**CITY AND BOROUGH OF WRANGELL, ALASKA**  
**Wrangell Barge Ramp Concrete Paving**

**ADDENDUM TO THE CONTRACT**

**Addendum No: 1**

# Sidewalk/Curb Replacement

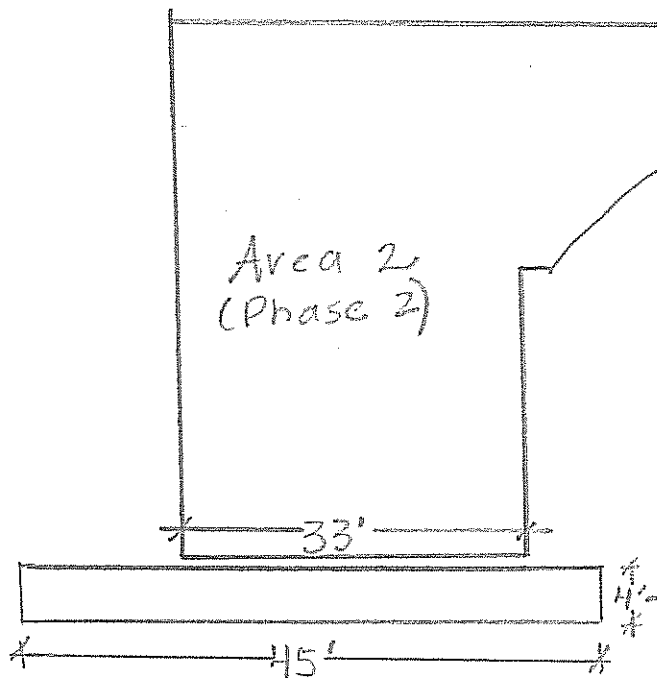
Add Drawing Sheet 10, Sidewalk Replacement (attached hereto)

Replace 45' of concrete sidewalk and curb  
Widen curb cut by five feet (5') to the  
east side of the opening. Cut at existing  
joints and provide minimum six feet (6')  
of sloped sidewalk. Match existing slope.  
6" thick sidewalk and curb.
